RESOLUTION NO. 92-1588

**Re: Request for Bids, #91B-49-SW,  
St. Johns Landfill Closure of Subarea 1**

**ADDENDUM NO. 2 to the Contract Documents for  
St. Johns Landfill Closure of Subarea 1**

**ADDENDUM NO. 1 to the Contract Documents for  
St. Johns Landfill Closure of Subarea 1**

ST. JOHN'S LANDFILL  
CLOSURE OF SUBAREA 1  
CONSTRUCTION SITE PLAN

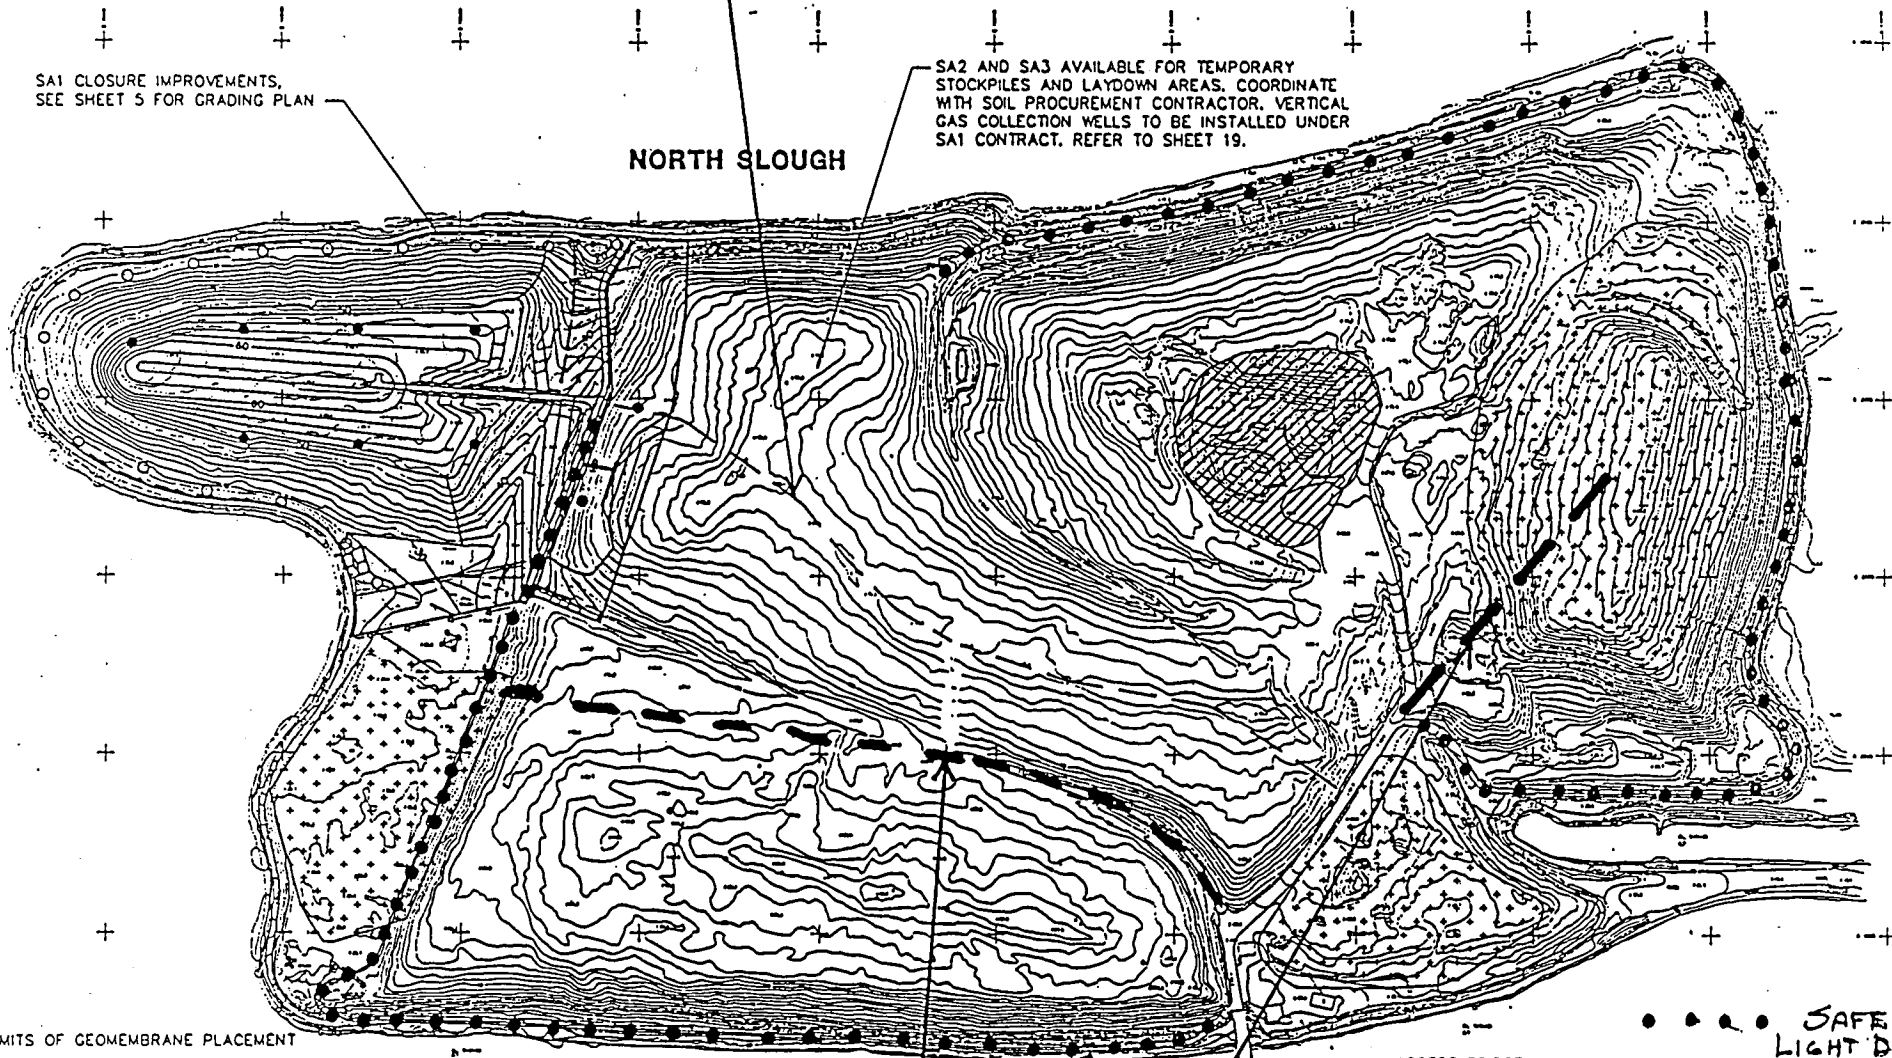
24. PLANS, Sheet 4, "Construction Site Plan":

DELETE note:

"Approximate Location of Temporary Haul Road by Soil Procurement Contractor"

DELETE  
SEE ADDENDUM No. 1
